SHEARON HARRIS NUCLEAR POWER PLANT, UNIT NO. 1
DOCKET NO. 50-400/LICENSE NO. NPF-63

FREQUENTLY ASKED QUESTIONS (FAQS), REQUESTING ADDITIONAL
GUIDANCE OR CLARIFICATION REGARDING TRANSITION TO NFPA-805
"PERFORMANCE BASED STANDARD FOR FIRE PROTECTION FOR LIGHT
WATER REACTOR ELECTRIC GENERATING PLANTS"

FAQ 06-0001

Figure B-4 Acceptable Manual Action in Fire Area Meeting 10 CFR 50, Appendix R, Section III.G.1 Separation Criteria

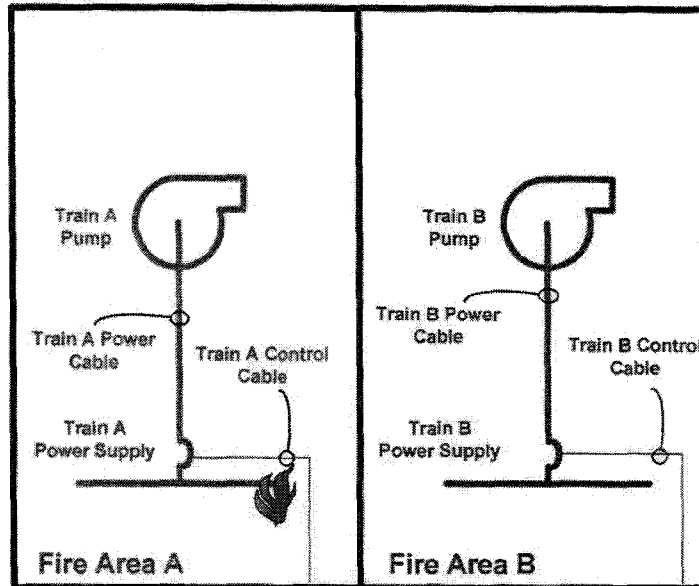
Figure B-4 added to NEI 04-02 reflects the concept of III.G.1 (fire affected train) manual actions.

Add new figures (B-4 & B-5) to NEI 04-02 to illustrate fire affected train operator manual actions (where credited train is protected in a fire area, e.g., 3-hour wrap, that includes the fire affected train operator manual action). Configurations shown are functionally equal for the fire affected train of equipment and as such would not require prior regulatory approval for change.

- Operation of equipment for which cables and equipment for the redundant safe shutdown train are located in separate fire areas thus meeting Section III.G.1 of 10 CFR 50, Appendix R (or applicable sections of NUREG-0800). See Figure B-4.

Fire Area A and B meet the separation criteria of 10 CFR 50 Appendix R Section III.G.1. A postulated fire in Fire Area A could result in the spurious starting of the Train A pump, which can be mitigated by a manual operator action to de-energize the Train A Power Supply to stop Pump A.

Figure B-5 Acceptable Manual Action in Fire Area Meeting 10 CFR 50, Appendix R, Section III.G.2 Compliant – Manual Action for Fire Affected Train

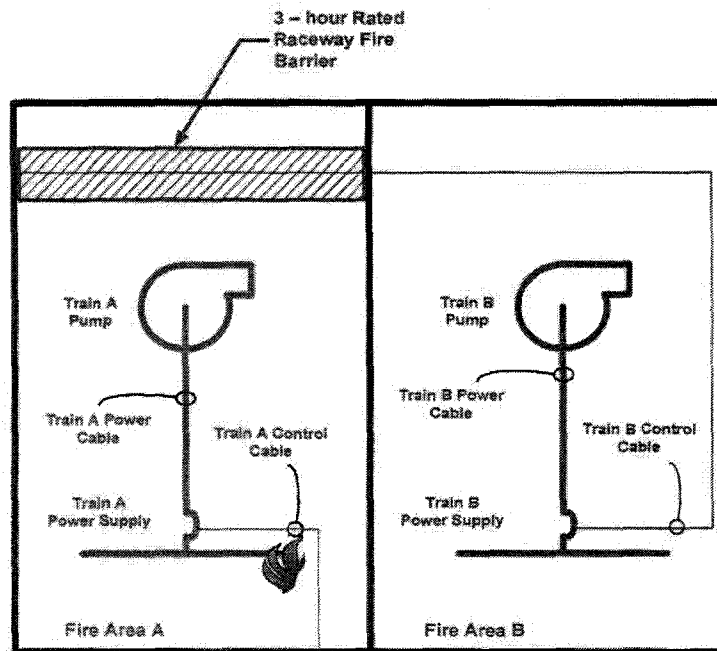
- Operation of fire affected equipment in fire areas that meet the separation requirements of Section III.G.2 of 10 CFR 50, Appendix R (or applicable sections of NUREG-0800) for redundant trains. See Figure B-5.

Fire Area B meets the separation criteria of 10 CFR 50 Appendix R Section III.G.2.a. A postulated fire in Fire Area A could result in the spurious starting of the non-credited Train A pump, which can be mitigated by a manual operator action to de-energize the Train A Power Supply to stop Pump A. This is functionally equivalent to Case in Figure B-4.
